ADDENDUM NUMBER TWO

RFQ # 7549344

**TITLE: Freshwater Access Site Improvements, Beach Pond, Exeter, RI,
DEM**

NOTICE OF ADDENDUM NUMBER TWO (2)

SK-2

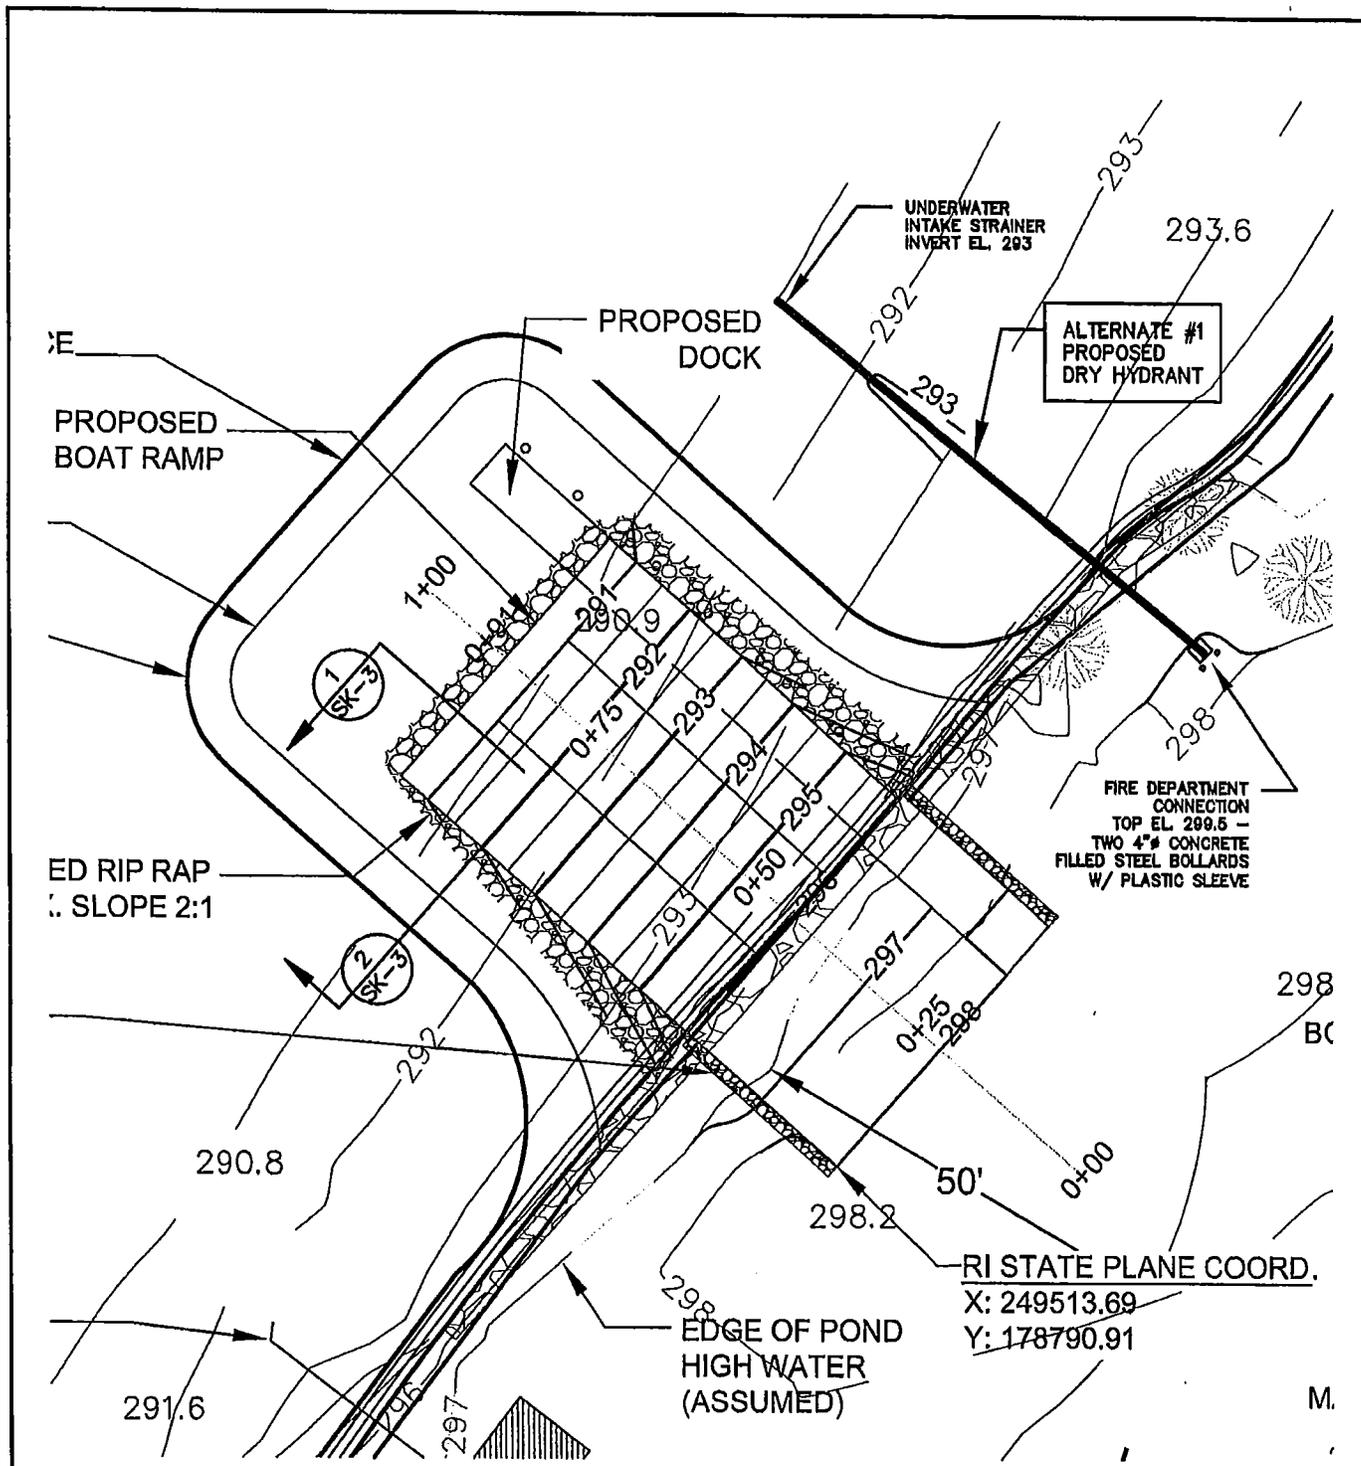
INSERT to contract documents attached specification Section 10521 – Dry Hydrant including attached plans labeled SK-1 & SK-2 provided for the construction of a dry hydrant adjacent to the proposed boat ramp to be considered as Alternate #1.

- F. The riser pipe shall rise at an angle of ninety (90) degrees from the horizontal suction line. The riser shall terminate with a six (6) inch PVC ninety (90) degree elbow, fire department connection, and cap. Due to a lack of available frost protection, the riser shall be constructed from 6" HDPE pipe appropriately joined to the PVC fittings.
- G. All exposed PVC surfaces shall be primed and painted white.
- H. Static lift should be kept as low as possible and shall not exceed fifteen (15) feet (measured from the centerline of the pumper intake, assumed to be three (3) feet above finish grade, to the top of the underwater intake strainer).
- I. Upon complete installation, smooth over all disturbed areas and plant grass seed or other vegetation to retard erosion.

Turbidity Curtains

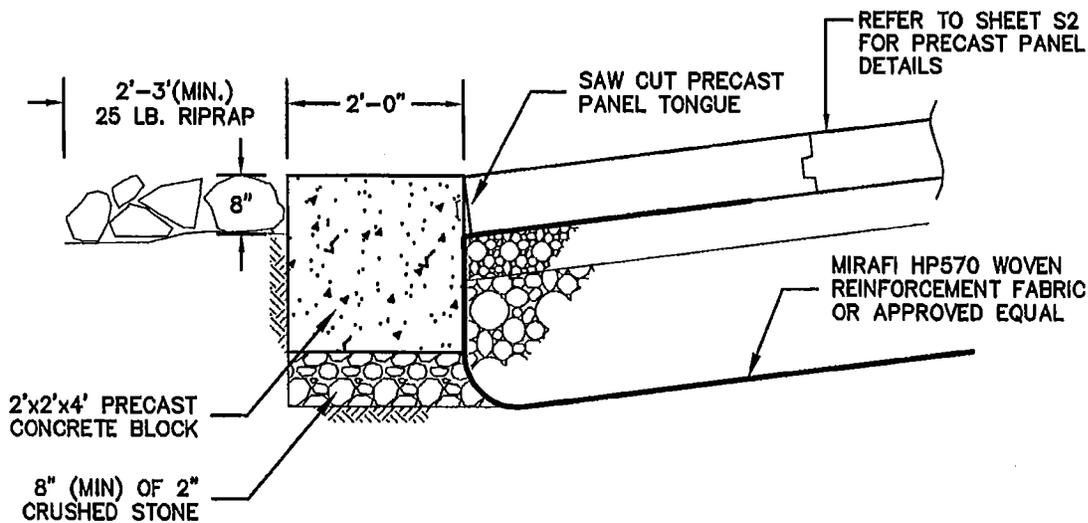
Q1) Regarding the weighted silt curtain that will be deployed in the pond. How deep is the pond in that area? Should the curtain be permeable or impermeable?

The depth of the pond in the vicinity of the boat ramp can be conservatively calculated based on the estimated high water elevation of 297. The bottom of the pond past the end of the boat ramp was not surveyed. The silt curtain shall conform with the 2014 RISESC Handbook (attached).

SK-3

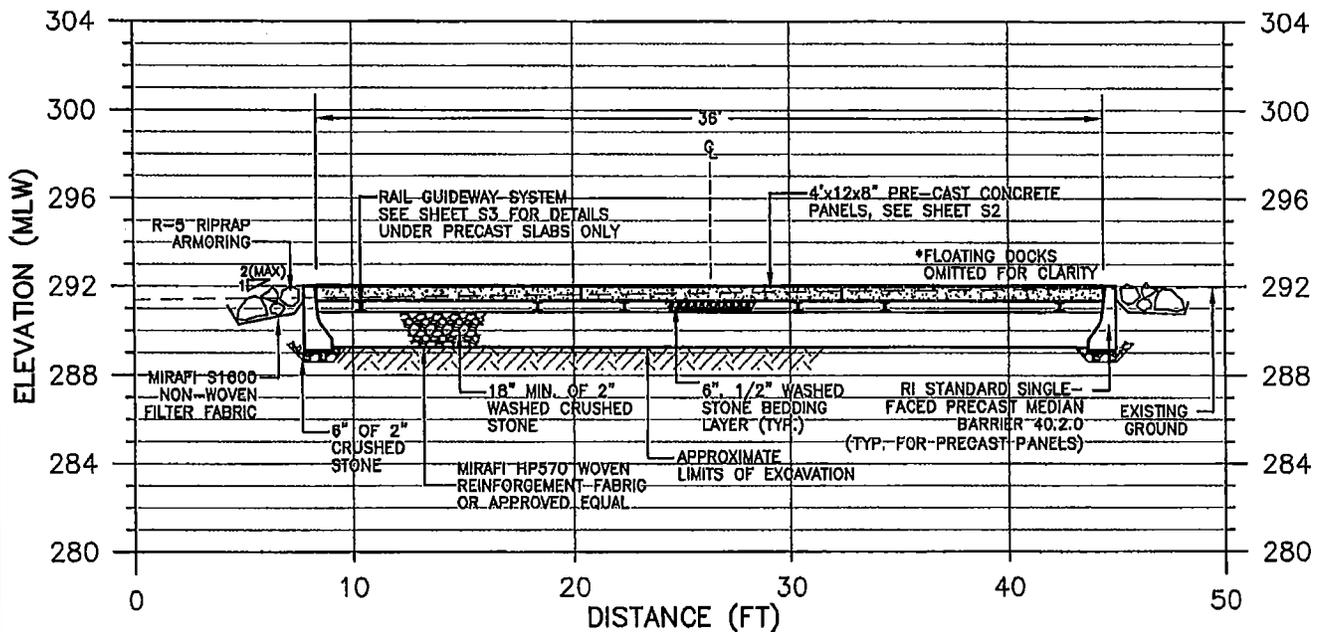
DELETE detail "3/S1 – Run-Off Slab Detail" from the contract drawings sheet S1.

REPLACE with detail "1/SK-3 – Run-Off Protection Detail" found on the attached plan labeled SK-3. This detail replaces the cast-in-place run-off slab with precast blocks. The precast blocks shall extend the entire width of the boat ramp.

INSERT detail "2/SK-3 – Boat Ramp Cross Section" found on the attached plan labeled SK-3. This detail is provided to further illustrate the intended boat ramp construction while also including provisions for a single-faced precast median barrier (RI Standard 40.2.0) to be installed along the sides of the precast boat ramp slabs, the addition of Mirafi HP570 woven reinforcement fabric as part of the boat ramp foundation, and further information relating to the riprap slope protection.
